BURLINGTON DEVELOPMENT REVIEW BOARD

Tuesday, June 1st, 2021, 5:00 PM

Agenda

To: Development Review Board
From: Mary O'Neil, AICP, Principal Planner
Date: June 1, 2021
RE: 77/79 Pine Street ZP21-0927CA ZP21-118OG

C2.1

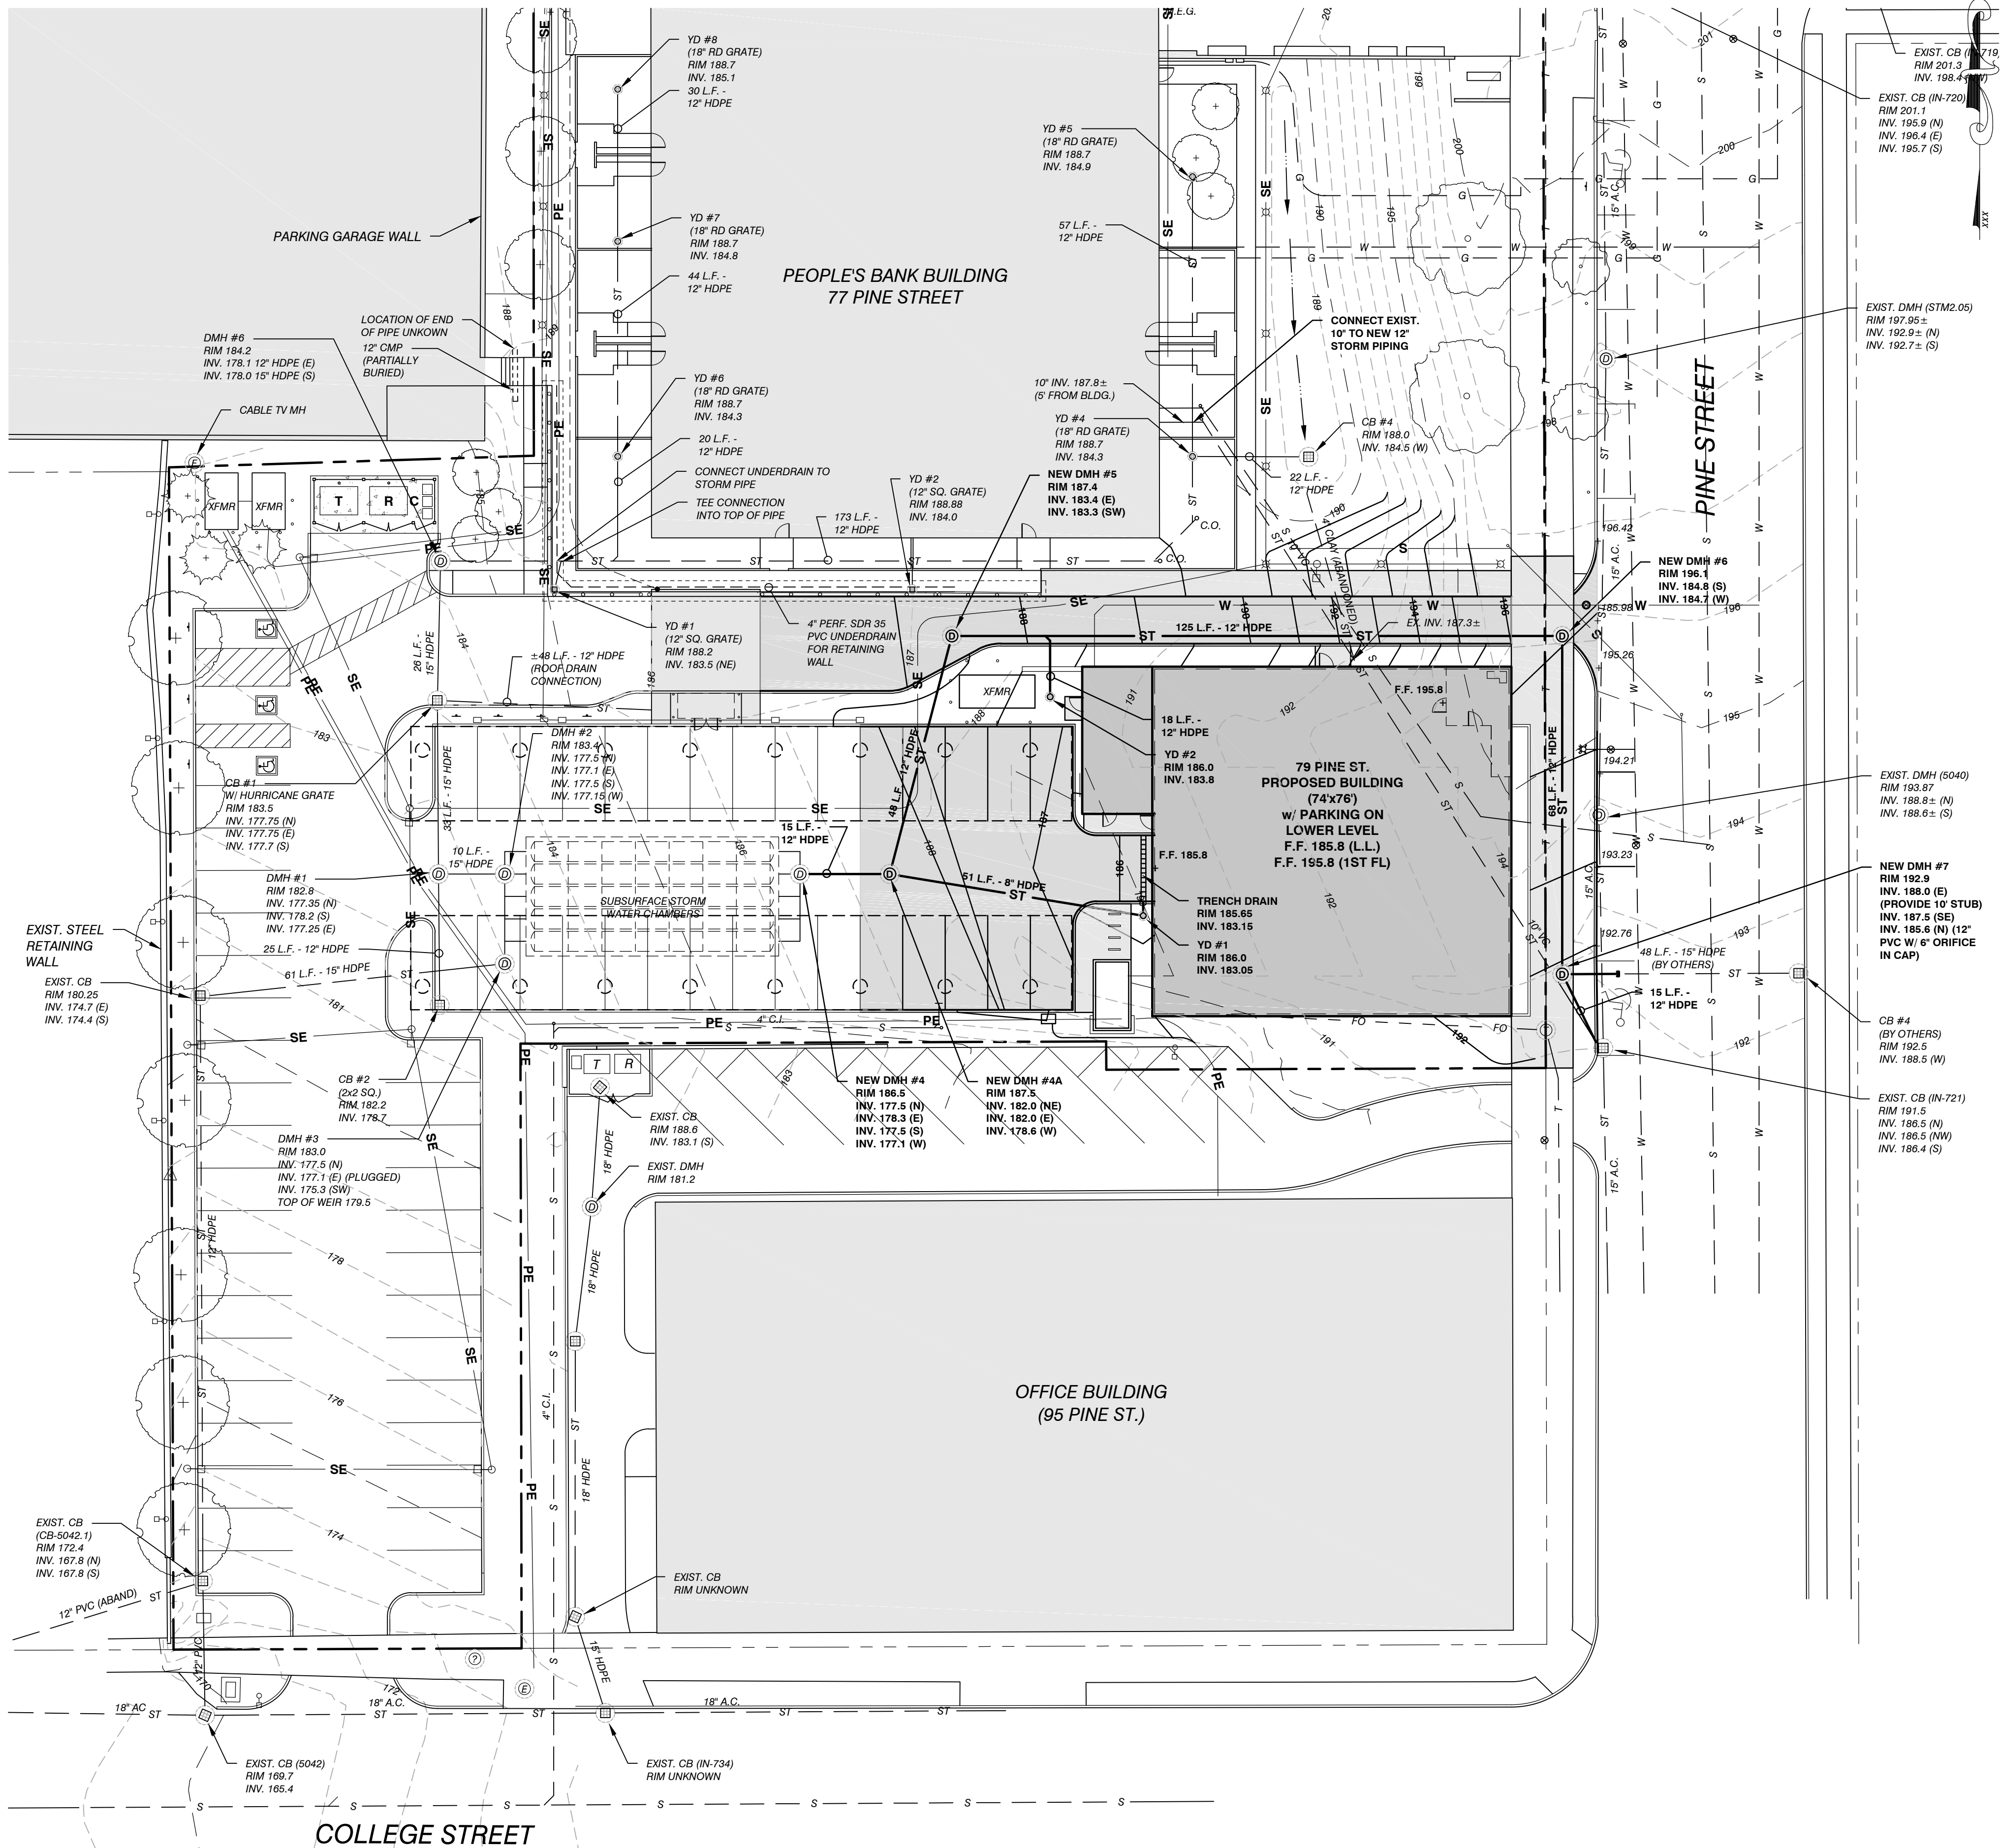
There is protected bicycle parking illustrated on plan A101 that will meet the long term requirement. Outdoor short-term bicycle parking will be provided west of the building; see C2.1.
